VIRGINIA DEPARTMENT OF TRANSPORTATION

MEMORANDUM

GENERAL SUBJECT: Traffic Signs		NUMBER: TE-301
		DATE: August 30, 2000
SPECIFIC SUBJECT: Rest Area/Welcome Center Signing		SUPERSEDES: TE-283
DIRECTED TO: District Administrators	SIGNATURE: <i>Ilona O. Kastenhofer</i>

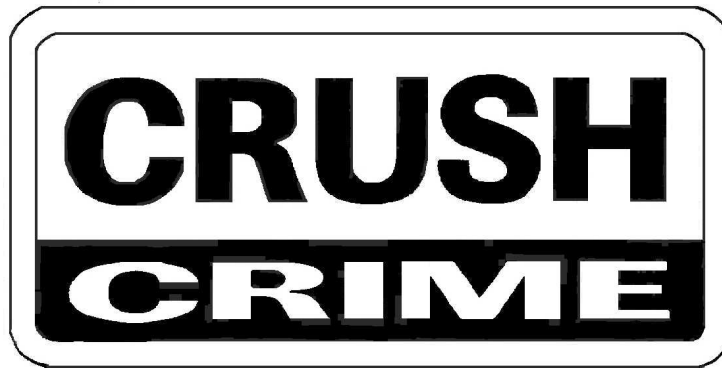
The Department has been requested by the State Police to remove the word "EMERGENCY" from Cellular #77 signing due to legislation (Senate Bill 148) passed during the 2000 session of the General Assembly. This legislation prevents any public safety agency from advertising or otherwise promoting the use of any number for emergency response service other than 911.

In an effort to promote security in our rest areas and welcome centers and to promote the *CRUSH CRIME* program, the Department, in cooperation with the State Police, has decided to install "REST AREA PATROLLED BY STATE POLICE FOR ASSISTANCE DIAL 1-800-XXX-XXXX CELLULAR #77" and "CRUSH CRIME" signs at each location.

The 800 number displayed on the sign shall be the State Police's Division Headquarters number for the area where the rest area/welcome center is located. Signs should be installed in the vicinity of the building in an area where it will be easily viewed by the public, but where the possibility of pedestrians accidentally making contact with the sign doesn't exist. Signs shall not be installed on the ramps. The exact location of the signs will be determined by the Central Office Maintenance Division in cooperation with the State Police's crime prevention specialist except for the location in Accomack County. The District Traffic Engineer in cooperation with the State Police's crime prevention specialist should determine the exact location in Accomack County. The signs shall be installed on the same post with the "CRUSH CRIME" sign on the bottom. Distance to the bottom of the "CRUSH CRIME" sign should be four feet with one inch spacing between the two signs. This memorandum is effective immediately and modification of the existing signs to change the word "EMERGENCY" to "ASSISTANCE" shall be completed by October 1, 2000.

SHAPE		Horizontal Rectangle	
COLOR	Message and Border:	White (Reflectorized)	
	Field:	Blue (Reflectorized)	
SIZE	Horizontal:	48"	
	Vertical:	36"	
MESSAGE	Line 1	Capitals:	4" D
	Line 2	Capitals:	4" D
	Line 3	Capitals:	4" D
	Line 4	Capitals:	2" C
	Line 5	Numerals:	2" C
	Line 6	Capitals, Symbol & Numerals:	2" C
BORDER WIDTH		$\frac{5}{8}$ "	
CORNER RADIUS		2"

Notes: Vertical spacing between the message and the border is $2\frac{7}{8}$ ". Vertical spacing between the lines of the 4" message is $2\frac{1}{2}$ ". Vertical spacing between the 4" message and the 2" message is 2". Vertical spacing between the lines of the 2" message is 2".
